To: Planning Section
Tipperary County Council
Civic Offices
Limerick Road
Nenagh

Re: Planning reference **2360047** – Development at Springfort Meadows, Limerick Road, Nenagh

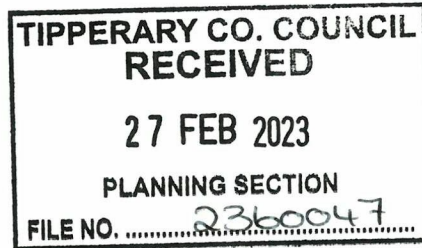
The estate as it is currently meets this requirement. The map below shows the existing open space and the table shows how the open space requirement is met.

The planning submission intends to develop **18 new houses** on the site of **Area 7**. If this is permitted to happen, the open space in the estate will drop to 13.4%. Also, **Area 6** was originally meant to be a site for a crèche and was never intended to be open space. If the proposed houses are constructed and the intended crèche is constructed at some point in the future, the open space will fall to 12.2%, well below the 15% open space requirement required by the Council.

Based on the professional advice we have received, the small size of **Area 4** and **Area 5** at the entrance road to the estate makes it difficult to consider them as “useable open space” that the Nenagh Development Plan looks for.

It is our opinion that the only way to ensure that the estate remains compliant with the Council’s own Development Plan for Nenagh is to reject this planning application. The site in **Area 7** has been used by the residents as open space since the estate was constructed over seventeen years ago, especially by the families in the back road of the estate who are not comfortable in letting our children play on the front green where we cannot see them.
